QUALITY ASSURANCE -- NON-CONFORMANCE REPORT

Report No: NCR-000261

NCR #: ZPMC-0235

Reference Description: Missed MT Indications on East Tower, Lift 3, Skin D Longitudinal Stiffener Weld

Draft of Welding Discontinuity:

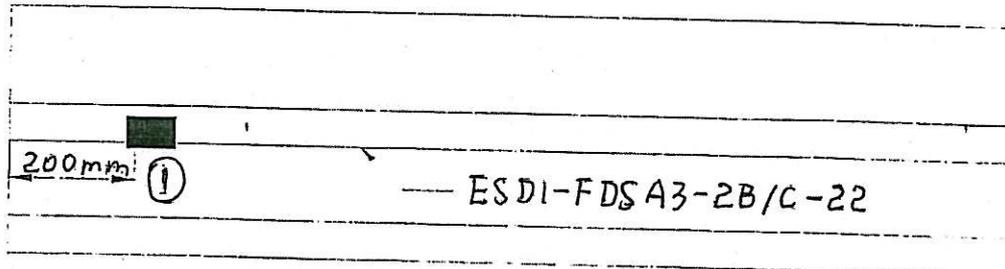
A longitudinal crack was detected by MT in weld ESD1-FDSA3-2B/C-22. Please see the detail position in the sketch below.

1. L=30mm;

- 1、 Grind repair area smoothly
- 2、 Verify with VT and MT to ensure no defects remain in the weld joint prior to welding ;
- 3、 QC will monitor and direct welder and grinder doing repair;
- 4、 QC shall monitor all welding passes being deposited;
- 5、 QC shall ensure all slag has been removed prior the deposition of next pass
- 6、 Preheat and maintain interpass temperature control in accordance with the WPS ;
- 7、 Perform NDT in accordance with contract requirements.
